# Technical Service Information

## 2001-03 “C/K” TRUCK WITH 4L60E TRANSMISSION SLIPPING 1-2 SHIFT OR SHUDDER

Figure 1

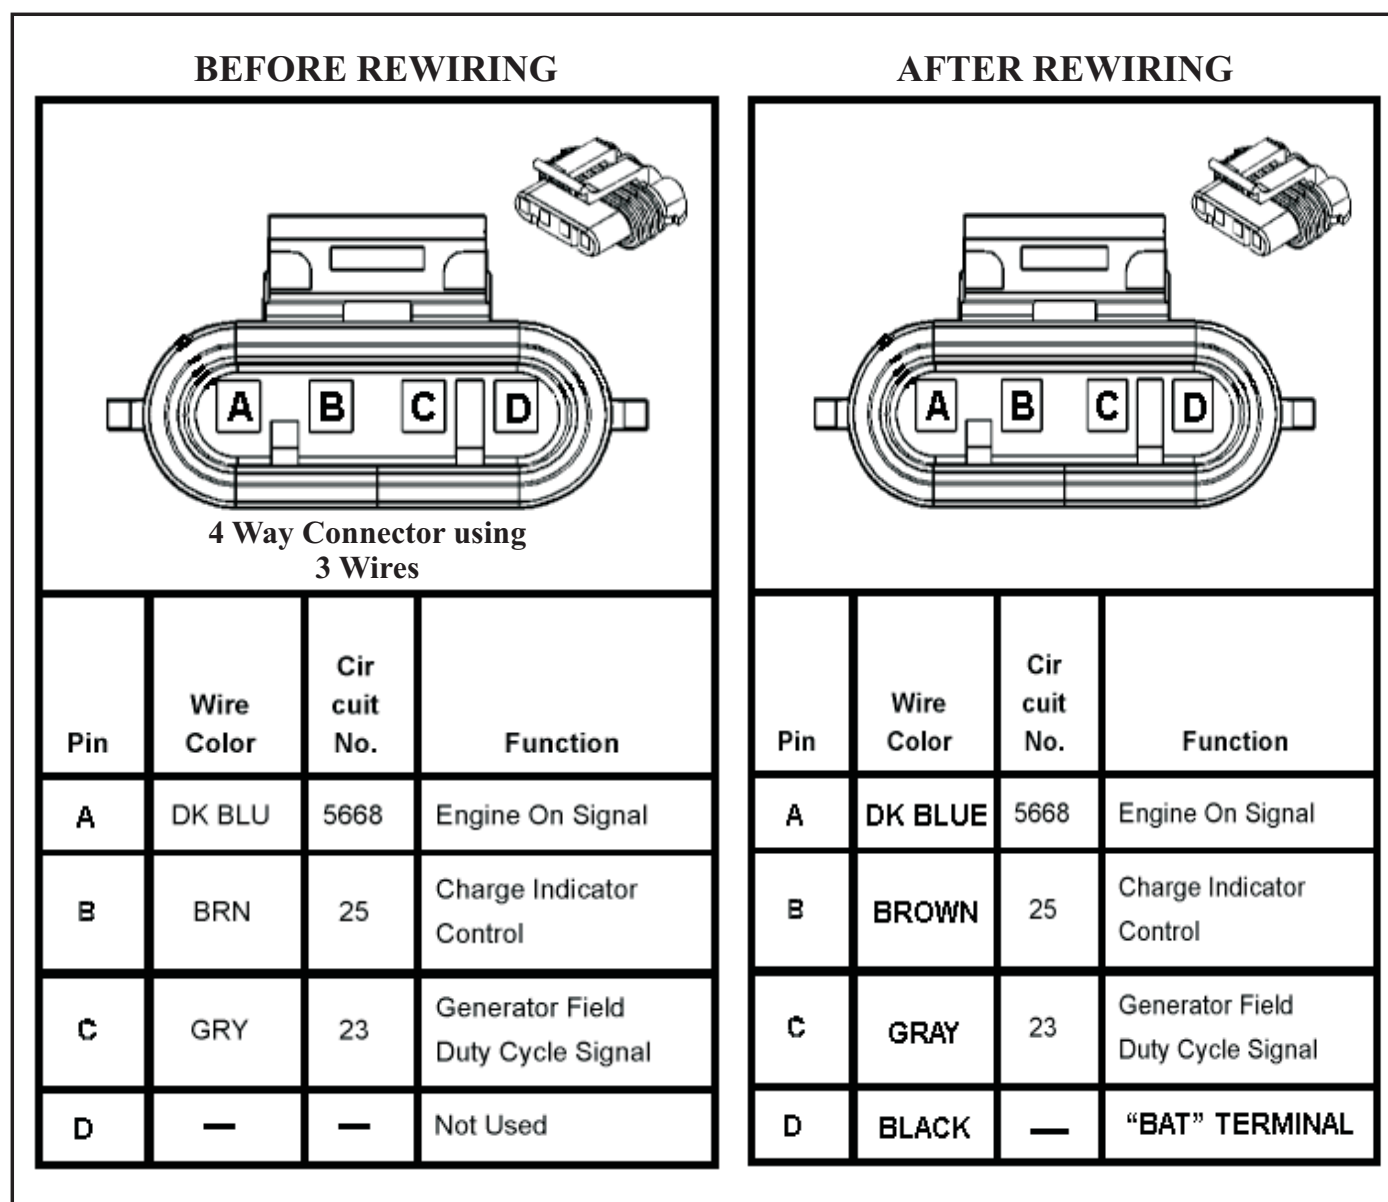
**CAUSE:** A 12 Hz electrical feedback from the charging circuit may be affecting the proper operation of the transmissions pressure control solenoid. This causes a fluctuation of line pressure which causes the above complaints when line pressure dips below normal.

**CORRECTION:** *First, with the complaint present, disconnect the four (4) way connector (with 2 or 3 wires in the connector) from the alternator. If the complaint no longer exists perform the procedure listed below.*

The alternator will require the installation of an external “Sense Lead” which is accomplished by adding a wire from the alternator four wire connector to the alternator output “BAT” terminal. The procedure is as follows as seen in figure 1:

- (1) Disconnect the negative cable from the battery/batteries.
- (2) Slide the protective boot on the alternator “BAT” terminal aside and remove the retainer and wire cable from the “BAT” terminal.

- (3) Unplug the alternator 4 cavity connector from the top of the alternator.
- (4) Inspect cavity “D” on the alternator connector for a **red** cavity plug.

- (a) If a **red** cavity plug is present, it is not necessary to replace the generator connector.  
Remove the **red** cavity plug and continue with step 9.

- (b) If a red cavity plug is NOT present, continue with the next step.
- (5) Remove and save the **orange** weather-pack seal from the 4 way connector.

- (6) Remove the 2 or 3 wires from the 4 way connector.
  - (a) On vehicles without Supplemental Brake Assist (SBA), install a **red** cavity plug into cavity “A” of the new 4 way connector.

- (b) On some 2003 models with “SBA”, install the **dark blue** (circuit 5668) wire of the vehicle wire harness into cavity “A” of the new 4 way connector.

- (7) Install the **brown** (circuit 25) wire of the vehicle wire harness into cavity “B” of the new 4 way connector.
- (8) Install the **gray** (circuit 23) wire of the vehicle wire harness into cavity “C” of the new 4 way connector.

- (9) Obtain a piece of 0.8mm (18 gauge) **black** wire, 254mm long (8”) long.
- (10) Install a **red** terminal seal, and terminal end, on one end of the new **black** wire.

- (11) Install the new **black** wire into cavity “D” of the new 4way connector.
- (12) Reinstall the connector seal from the original connector, to the new connector.

- (13) Plug the 4 way connector into the alternator.
- (14) Route the **black** wire to the alternator “BAT” terminal, sliding the wire into the small end to the output terminal boot along side the alternator output wire.

- (15) Crimp and solder the ring terminal on the open end of the new **black** wire.
- (16) Place the alternator output wire and the new **black** wire onto the alternator “BAT” terminal and install the retainer. Connect and tighten the “BAT” terminal retainer to 80 in. lb. (9 N.m).

- (17) Connect and tighten battery cable to 13 ft. lbs. (17 N.m).
